Re: 49 CFR Part 573; Recall of Mercedes-Benz SLK (170) Tail Lamps

Re: Recall Campaign 2006080005 – Update - Replace Tail Lamps, Model 170 Model Year 1998 – 2000

Campaign No. 2006080005, November 2006

SUBJECT: **MODEL 170, MODEL YEAR 1998-2000**
REPLACE TAIL LAMPS

Figure 1

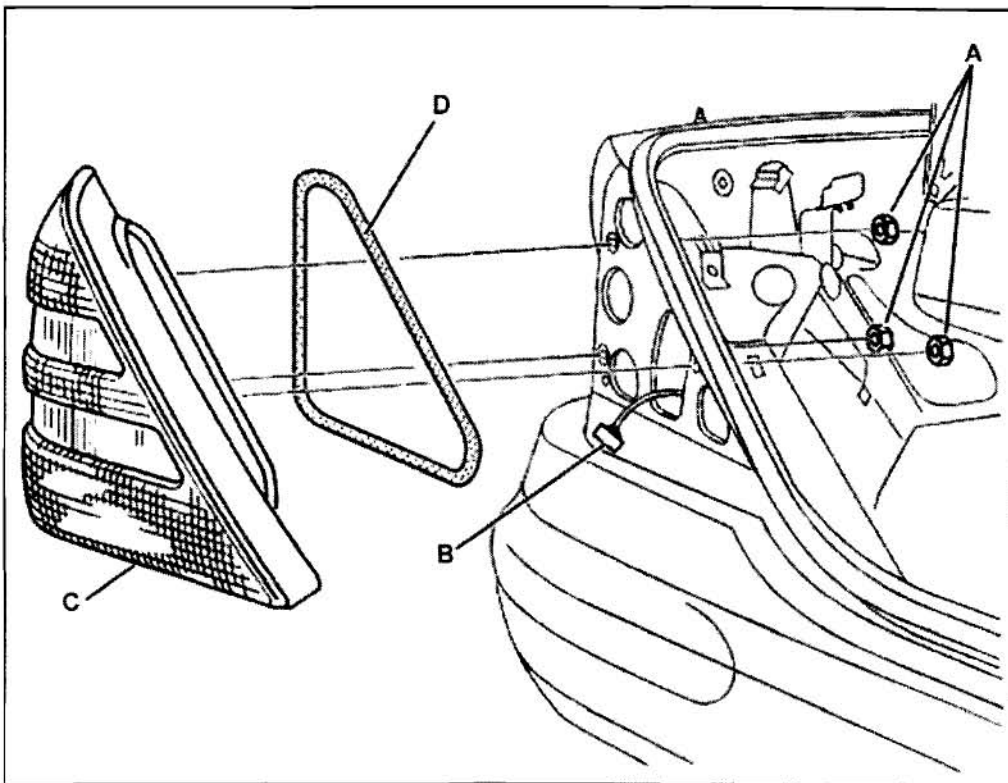
1. Open trunk lid.
2. Remove first-aid kit on left side; remove flap in wheelhouse paneling and CD changer (if applicable) on right side.
3. Remove nuts (A, Figure 1).
4. Disconnect electrical connector (B).
5. Replace tail lamps (C) on both sides of vehicle.

Ensure to install and position seal (D) correctly when installing new tail lamp.

Figure 2

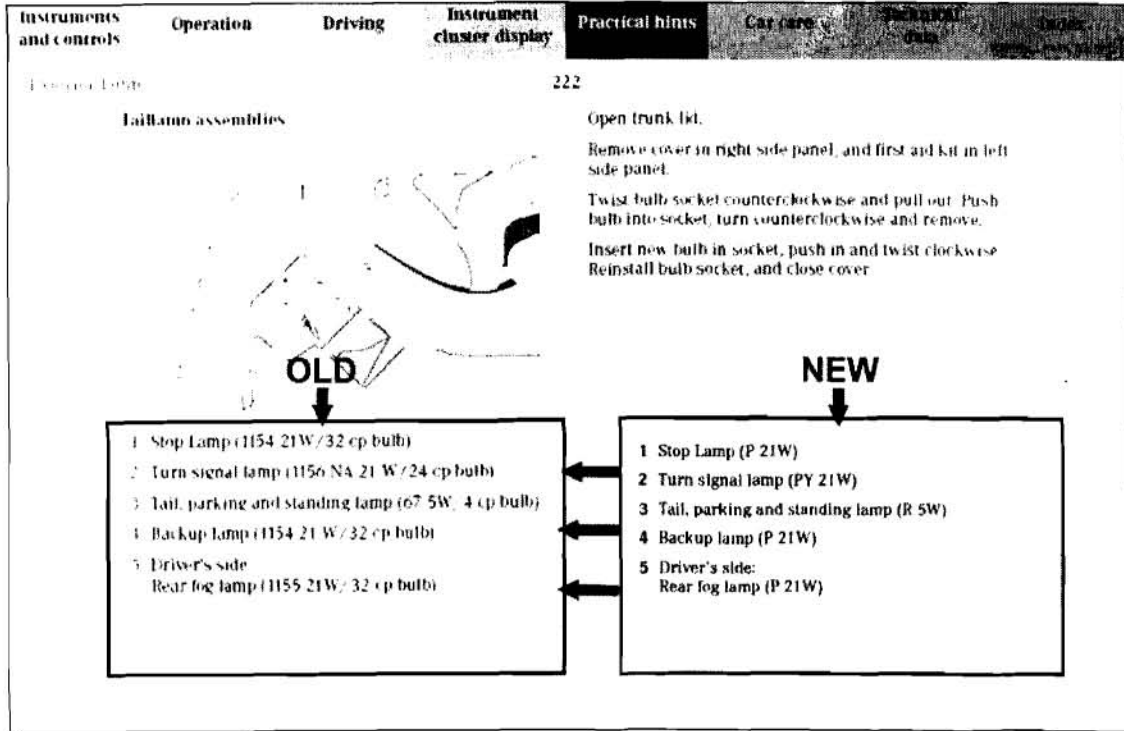
- 1 Stop Lamp (1154 21W/32 cp bulb)
- 2 Turn signal lamp (1156 NA 21 W/24 cp bulb)
- 3 Tail, parking and standing lamp (67 5W/4 cp bulb)
- 4 Backup lamp (1154 21 W/32 cp bulb)
- Driver's side:
 - Rear fog lamp (1155 21W/32 cp bulb)

7. Place new label over previous lamp specifications in Operator's Manual as shown in Figure 2 for Model Years 1998-2000.

- 1 Stop Lamp (P 21W)
- 2 Turn signal lamp (PY 21W)
- 3 Tail, parking and standing lamp (R 5W)
- 4 Backup lamp (P 21W)
- 5 Driver's side:
 - Rear fog lamp (P 21W)
